Subject: Proposed Silesia Properties, L.P. Permit No. WQ0015835001

I am submitting these comments on behalf of the Greater Edwards Aquifer Alliance regarding the Texas Land Application Permit (WQ0015835001) proposed for Silesia Properties, LP. The propose permit would authorize wastewater treatment and subsurface drip dispersal system disposal for 0.365 million gallons per day into the Honey Creek watershed upstream of the Honey Creek State Natural Area.

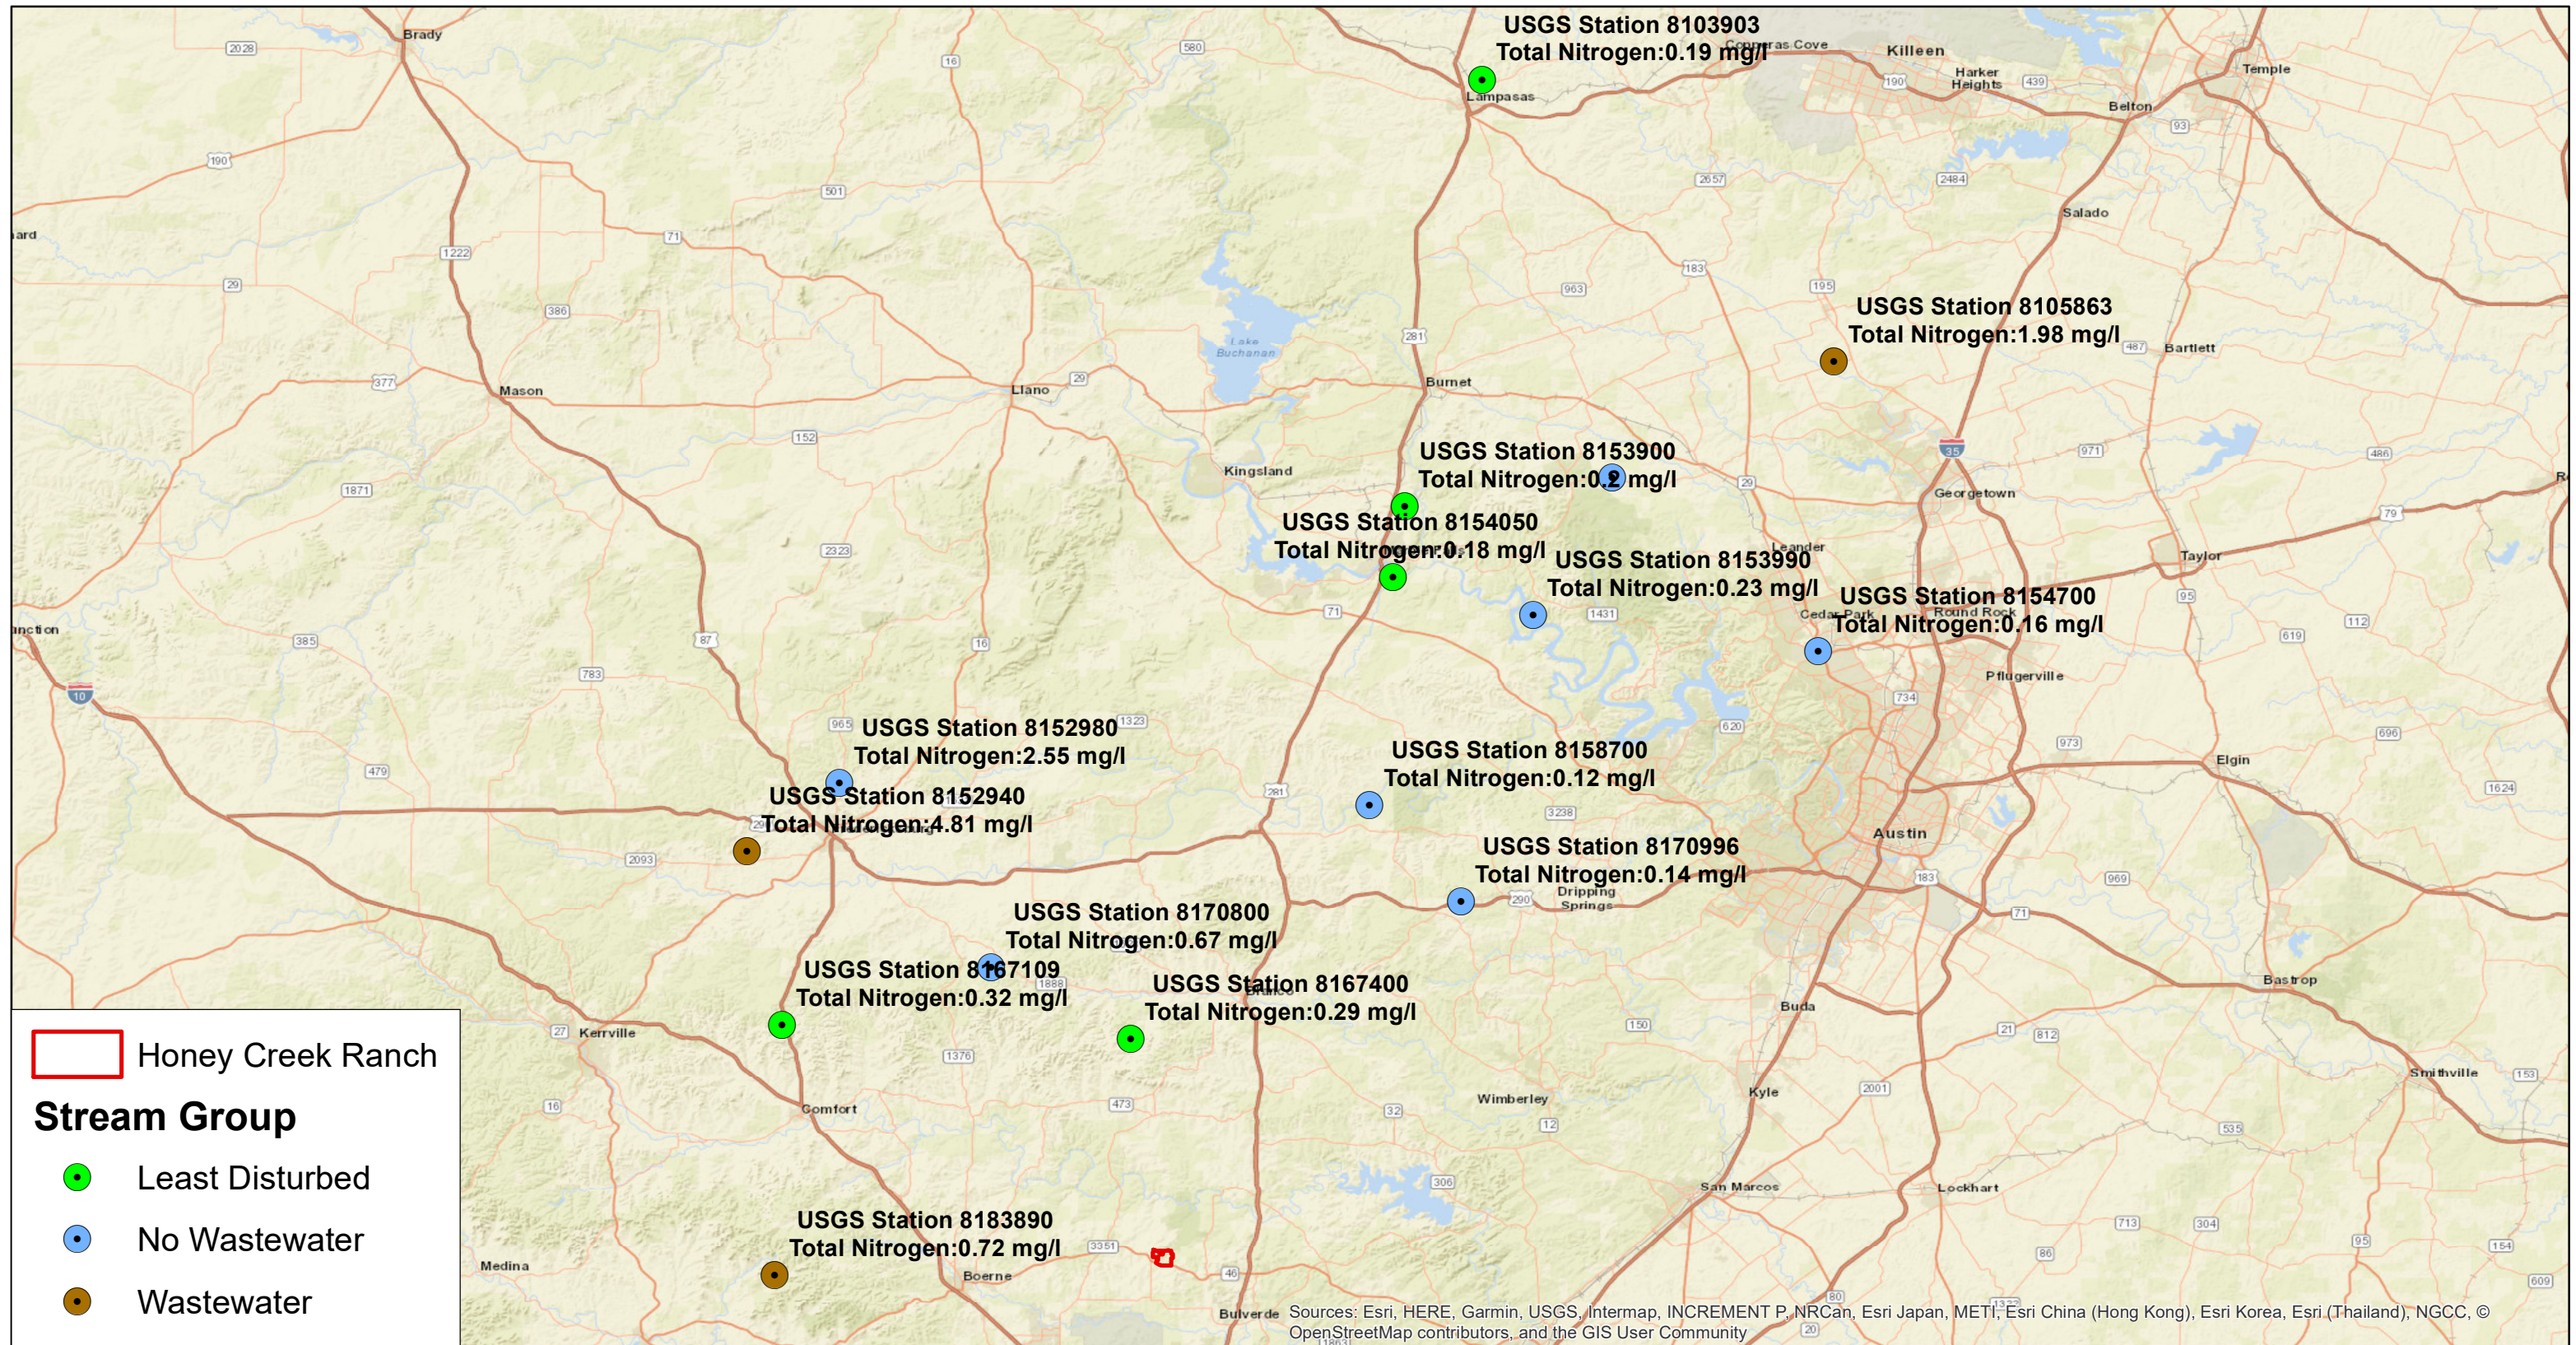
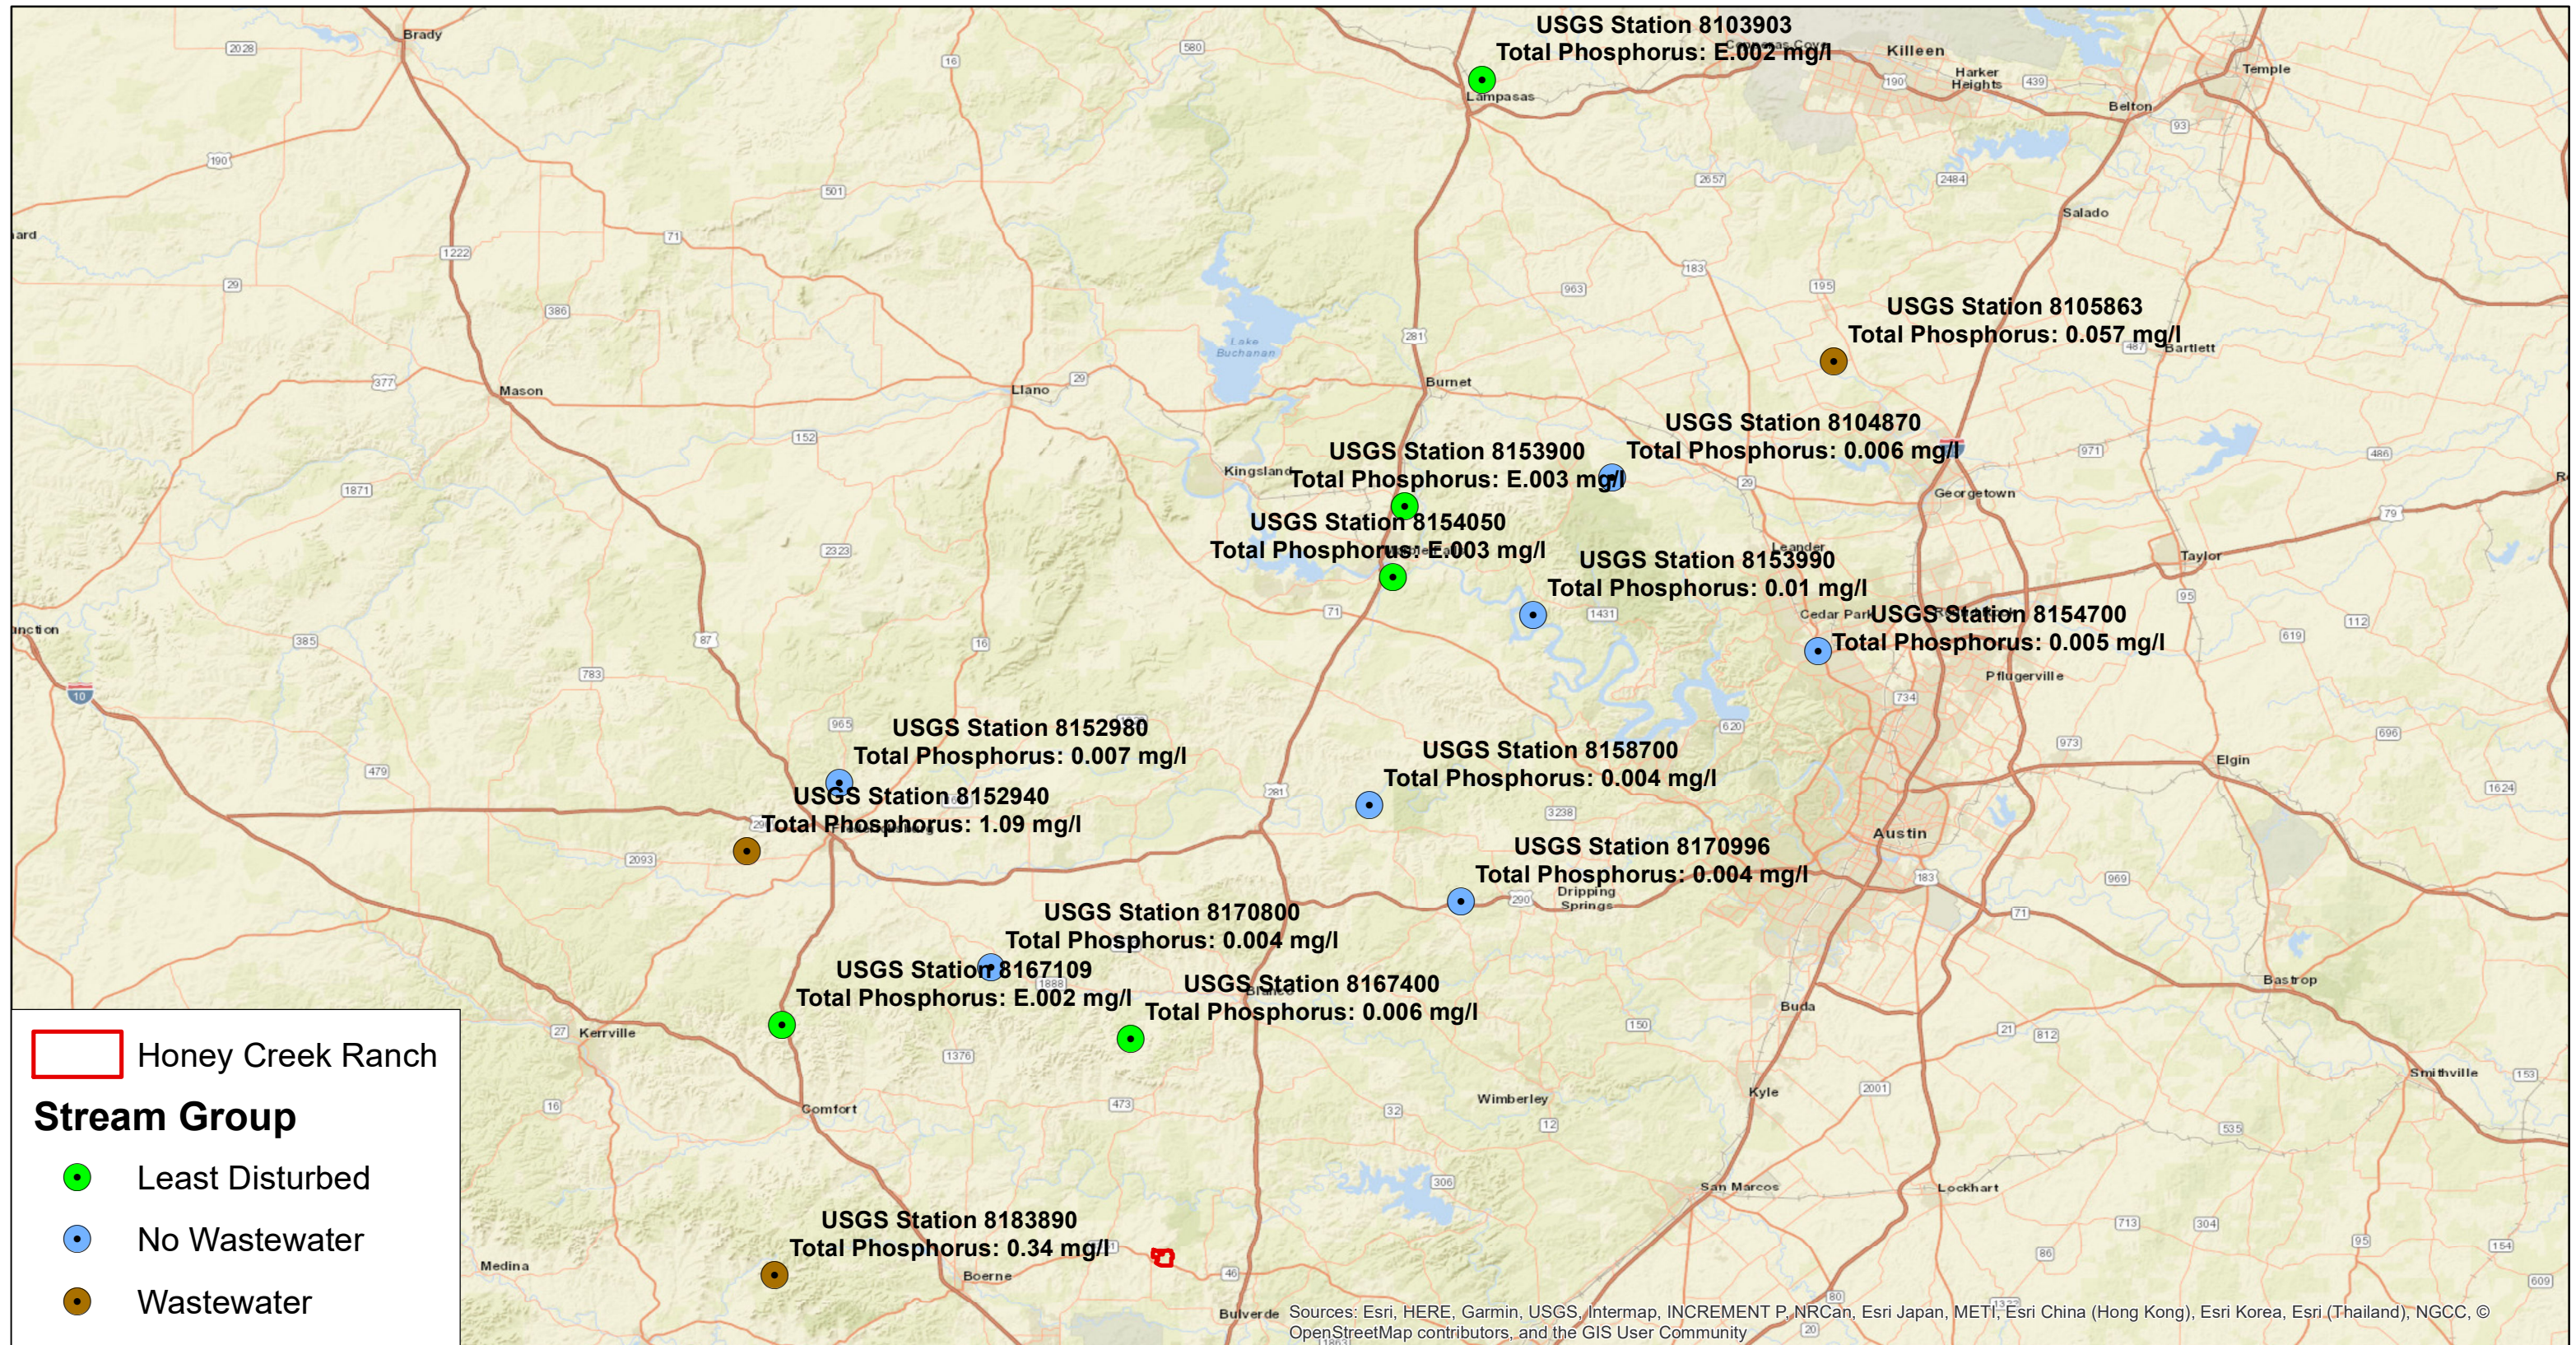
Figures 2, 3 and 4 show the low natural nutrient concentrations in unimpacted streams northwest, north, and northeast of the proposed discharge. Effluent nutrient concentrations that could be legally discharged under the proposed draft terms are significantly higher than these natural concentrations.

The proposed wastewater permit would allow effluent with nutrient concentrations as much as several hundred to a thousand times higher than those measured in unimpacted Texas hill country streams. Even using land effluent disposal and stream dilution, the proposed permit terms would not control degradation from significant increases in stream nutrient concentrations. As demonstrated in the paragraphs below, stream degradation from escalating nutrient loads into Texas hill country streams have been observed and documented for other land disposal wastewater systems. See my report in Attachment 2.
